button30mm R2

Sheet: /
File: button30mm_rev2.kicad_sch

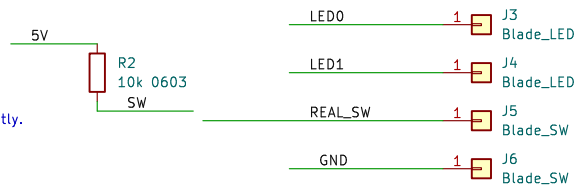
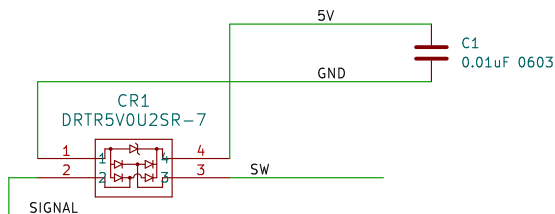
Rev2:
Added 2 pullup resistors.
Added ESD diode for SW and SIGNAL.
Enlarged SW slots.
Moved SW slots.
Added solder jumpers to disconnect 'signal' from CPU, and connect button and LED directly.
